Proposed Modifications to Glenn-Colusa Canal Bridge Design for COLUSA GENERATING STATION Colusa County, California

August 2007

E&L Westcoast, LLC

**APPLICATION FOR CERTIFICATION (06-AFC-9)
FOR THE COLUSA GENERATING STATION
BRIDGE DESIGN MODIFICATION**

REVISED GLENN-COLUSA CANAL BRIDGE DESIGN AND STAGING AREA

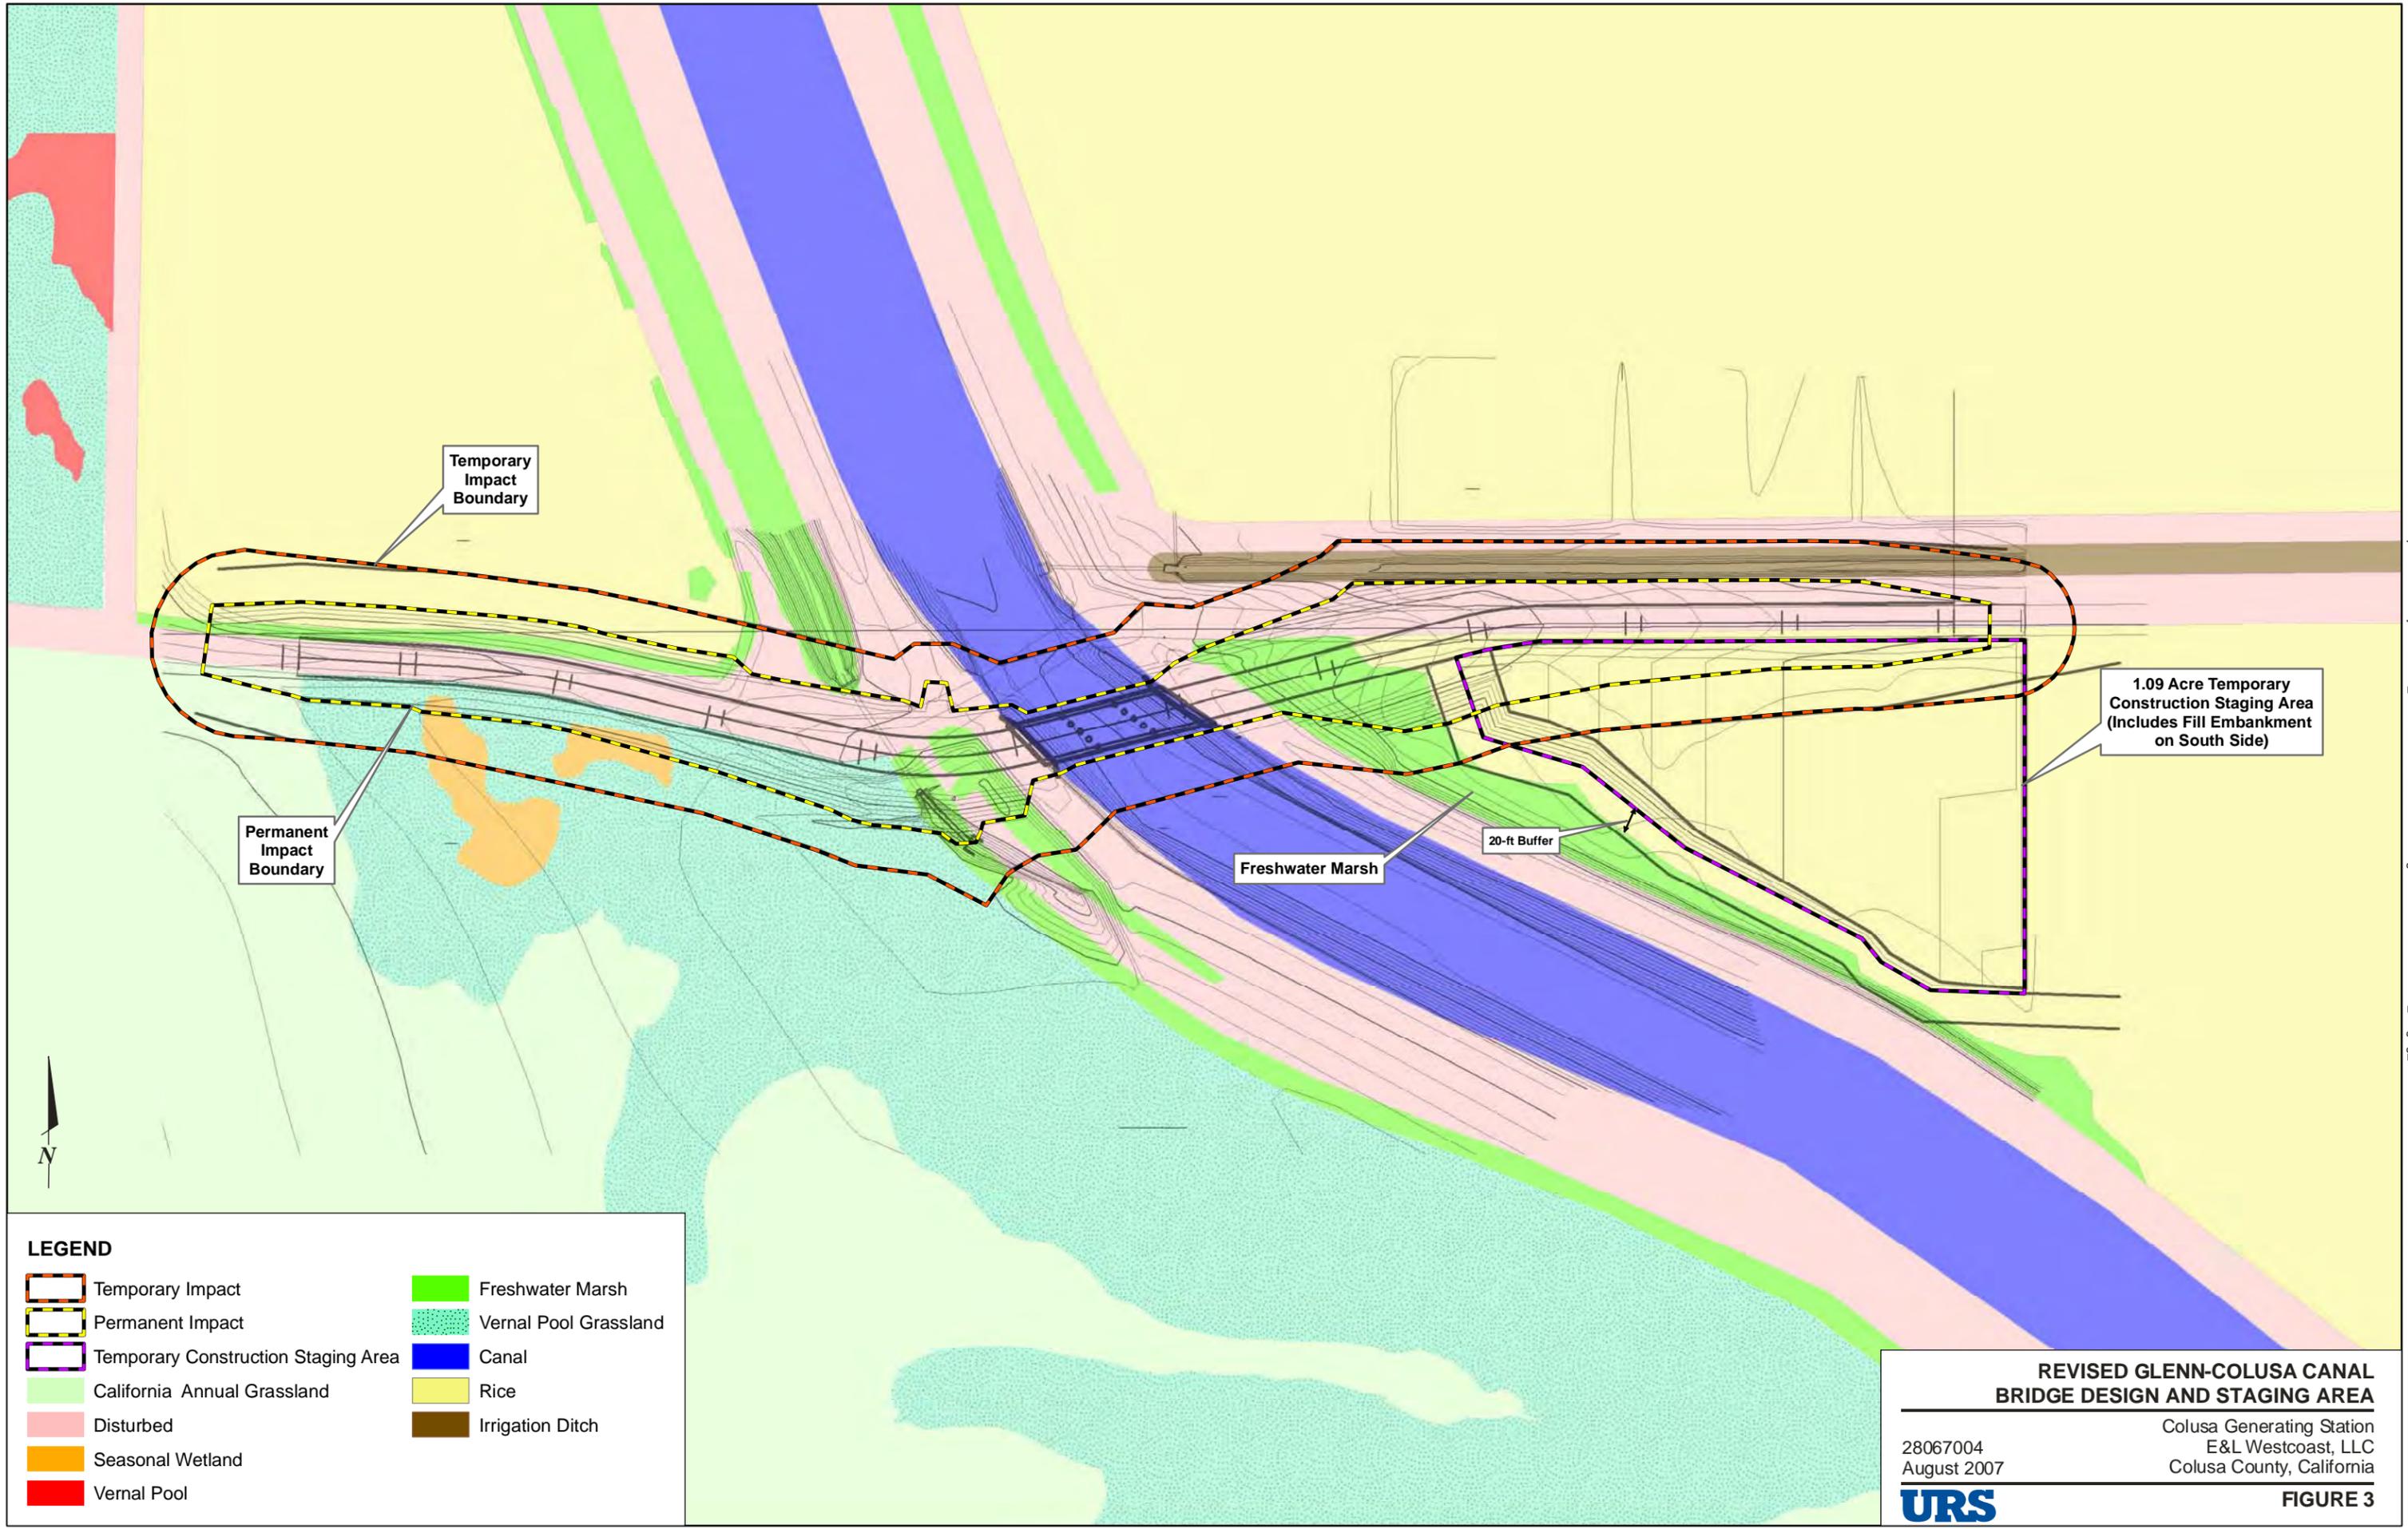
The current proposal is to construct a replacement bridge to the south of the existing bridge rather than to the north (Figure 3). The east approach will be located approximately 75 feet south of the existing bridge, and the west approach will be located about 45 feet south. Similar to the previous bridge design, the access road on both sides will be realigned to straighten and widen the approaches to allow for unimpeded two-way traffic, re-aligning with the current Dirks Road right-of-way as soon as practical. A retainer wall will be placed along the northern side of Dirks Road, on the east side of the replacement bridge, to enable the continued use of the current irrigation canal.

The replacement bridge will be approximately 100 feet long by 30 feet wide and will be a three-span bridge (rather than a free-span design as previously proposed). This would provide for two 12-foot lanes with 3-foot shoulders giving unimpeded two-way traffic flow, rated for the heaviest equipment for the plant, and will exceed HS-20 rating per AASHTO standards. Two rows of five piers will be constructed in the canal to support the bridge; designed and oriented to reduce impeding the flow of water and to minimize the collection of floating debris. Sheet piles will be installed to construct a temporary cofferdam around each row of piers. The inside of the cofferdam will be dewatered and the water will be released back into the canal downstream of the cofferdam. The bridge will be fitted with side guard rails and will be striped to permit safe passage of traffic.

Maximum permanent disturbance is limited to the realignment of the approach roads and backfilling the area (70 by 500 feet) on both sides of the bridge (rather than 40 by 100 feet, as previously proposed). Land disturbance for the current bridge design will involve 1.6 acres of permanent operational impact (rather than 1 acre, as previously proposed).

Under this proposal, the existing bridge will be removed (rather than left in place, as previously proposed). The removal of the existing bridge will occur after the new bridge is constructed to allow continued access over the Glenn-Colusa Canal. The concrete deck and the three sets of five piers associated with the existing bridge will be removed. The piers will be cut off at the mud line and removed during low water conditions, which will allow the work to be done without placing heavy equipment into the canal. Removal of the existing bridge piers will offset potential impacts of the new piers on the flow of water in the canal. The two bridge abutments supporting the existing bridge will be left in place to eliminate construction impacts to the canal embankments. This will not affect the operation of the canal. The original bridge approaches will be final-graded to match the surrounding land contours and seeded with grass native to the region.
